CONDITION 6 SURFACE WATER

Project:
PROFILE PARK POWER PLANT

Title:
PROPOSED SITE DRAINAGE

Drawing No.: **11069-2010 P04** Revision:

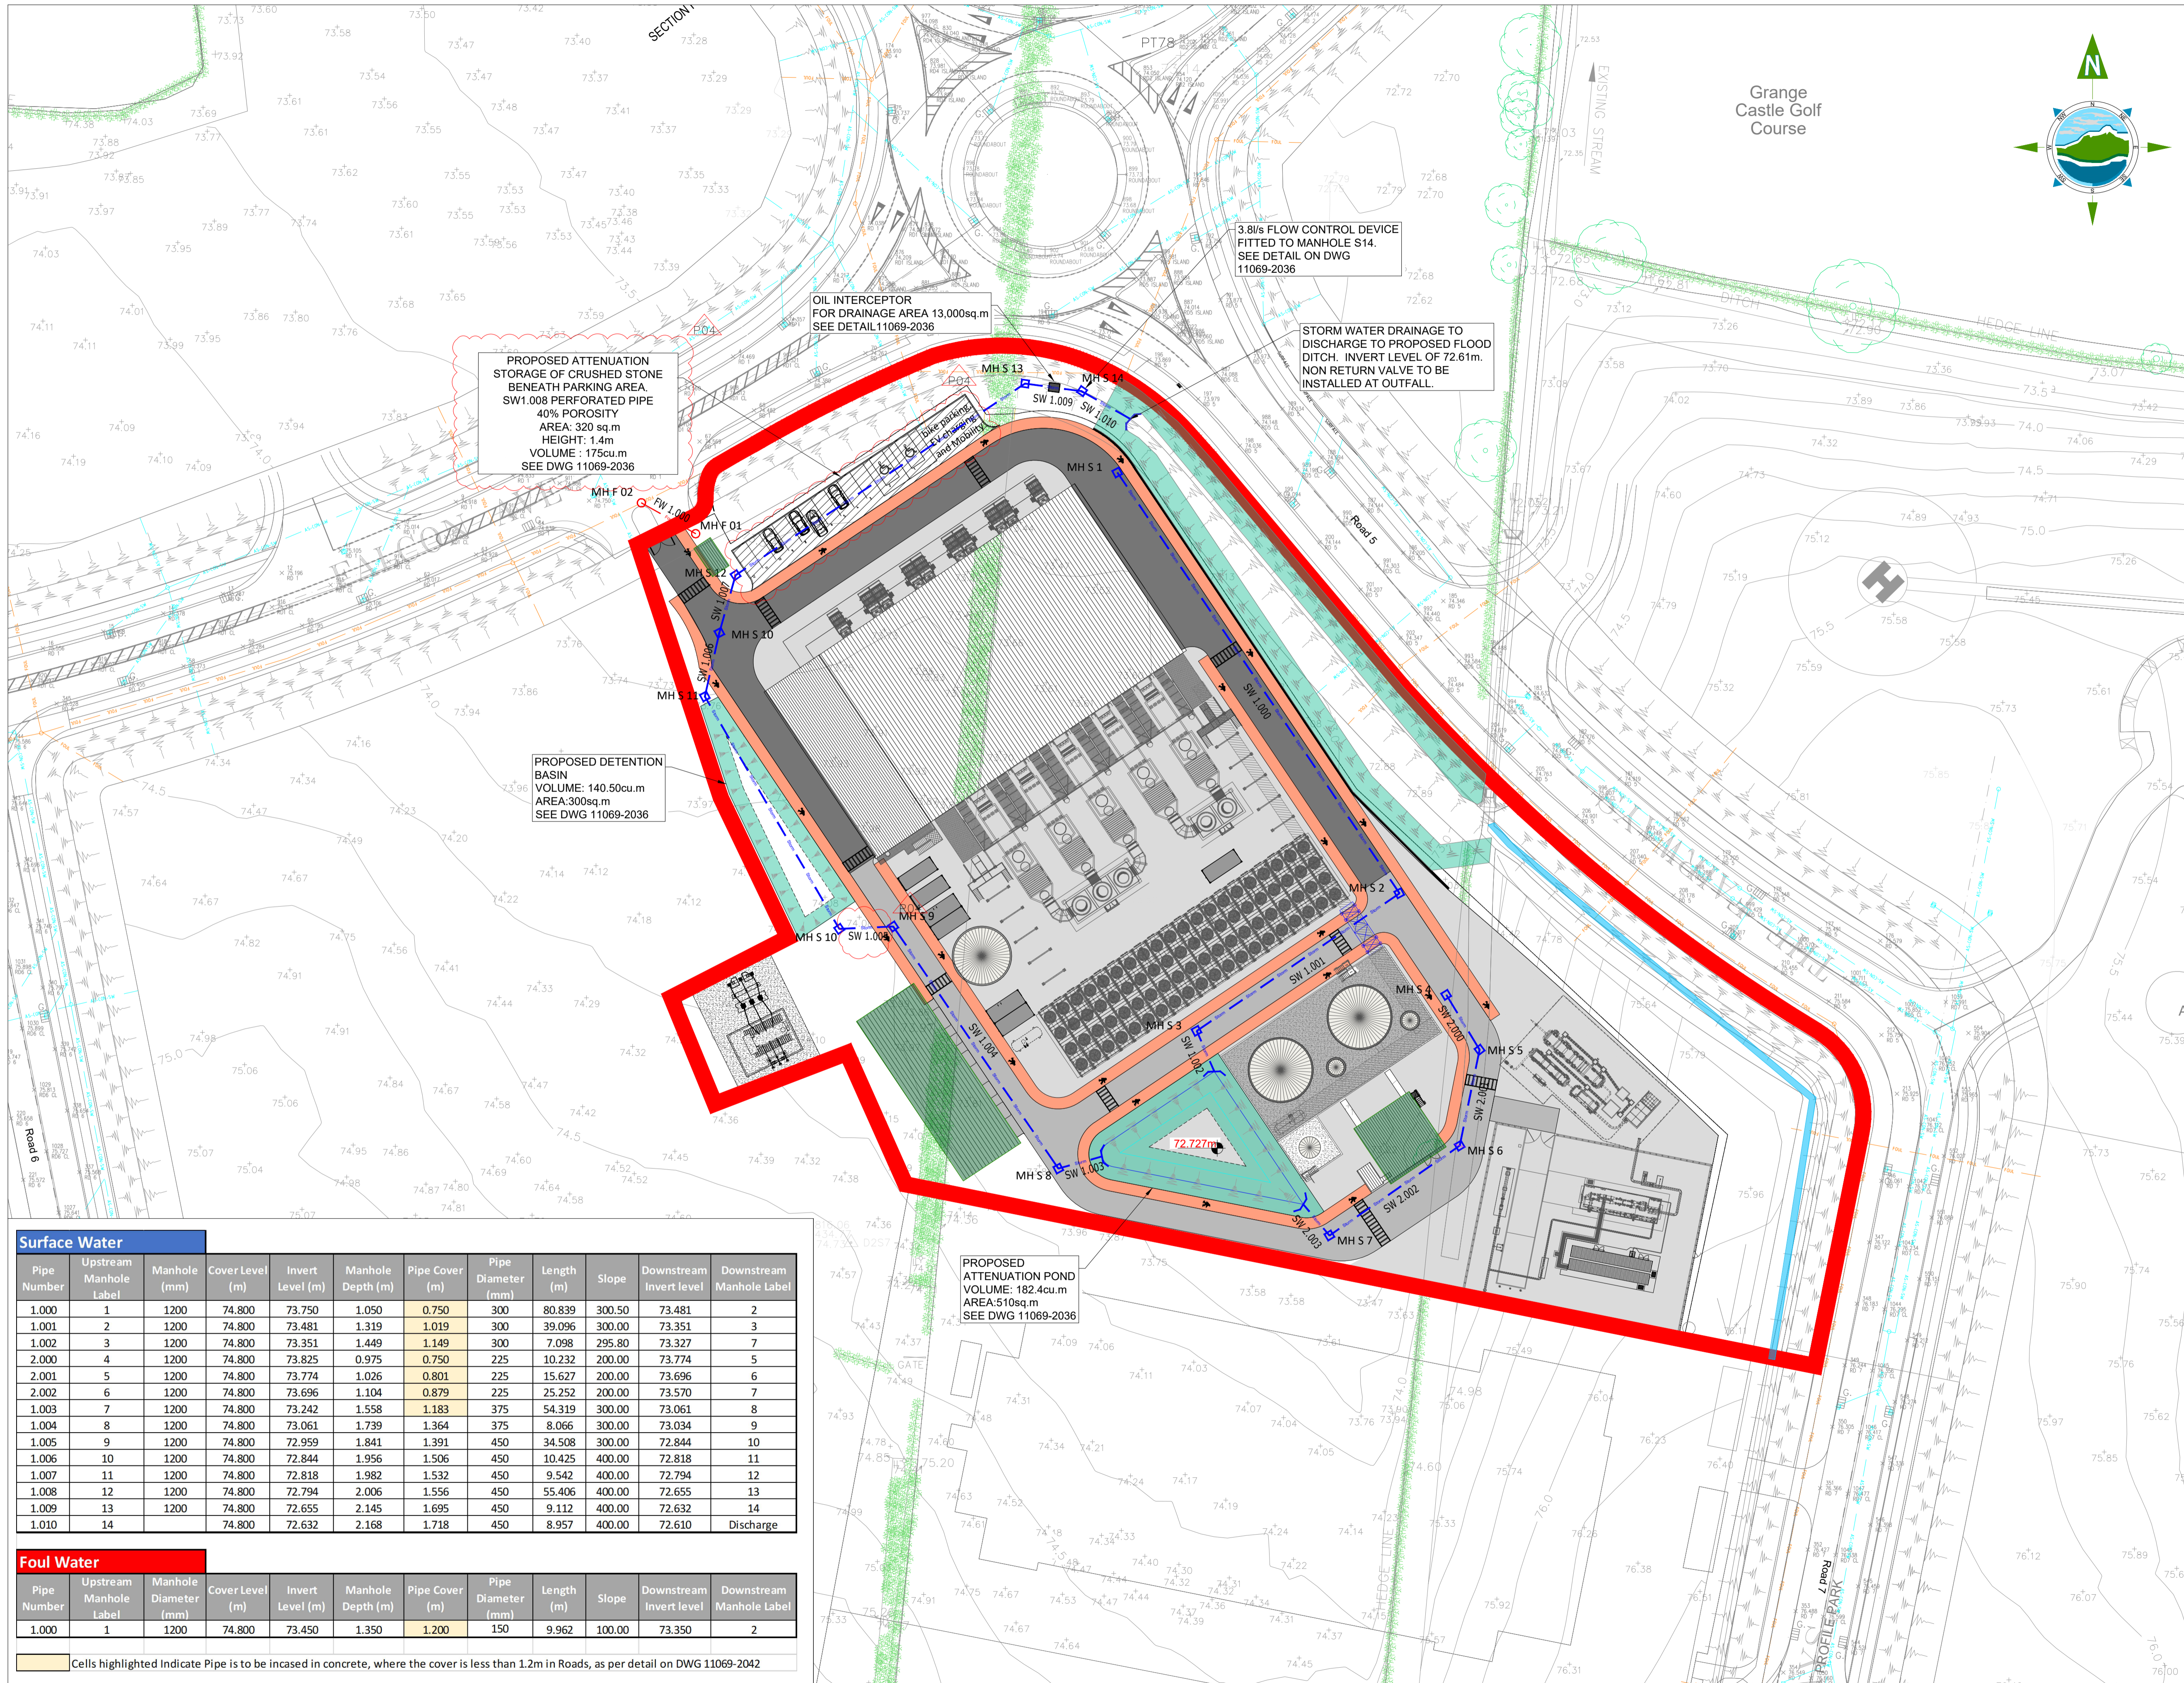
(a) Prior to commencement of development, the applicant shall submit a drawing showing where and how surface water discharge from site will be limited to a maximum of 3.8 litres/second.

(b) Prior to the commencement of development, the applicant shall submit revised drawings which provide adequate SuDS and omit the underground attenuation and petrol interceptors, unless otherwise agreed in writing by the Planning Authority.

Please refer to the enclosed updated site layout plan no. 11063-2010_P04, which shows the location of the proposed Hydrobrake at manhole S14. The design head for the Hydrobrake is 1.80m.

The originally proposed underground attenuation tank has now been omitted from the design and replaced with a cleaned crushed stone detention basin to allow for storage of surface water runoff, treatment and infiltration of stored water into the groundwater. Please refer to the enclosed updated plan no.s 11069-2010_P04 and 11069_2036_P05.

With regards to the proposed introduction of a petrol interceptor, we note that SDCC's SUDs guide requires a risk assessment and consultation with the appropriate licencing authority for sites with a 'High Pollution Hazard Level'. We would consider the proposed use of the power plant and associated use and storage of fuels and oils on site, to be a site of high pollution hazard level. For this reason and in anticipation of a request from the EPA for a petrol interceptor, we are proposing to retain a petrol interceptor for the design of this site. GIL are familiar with the upkeep and maintenance of petrol interceptors through the management of a similar powerplant site, the Whitegate Power Plant. If it would be of assistance to South Dublin County Council, GIL are happy to provide a protocol setting out a maintenance procedure for the petrol interceptor at this site.
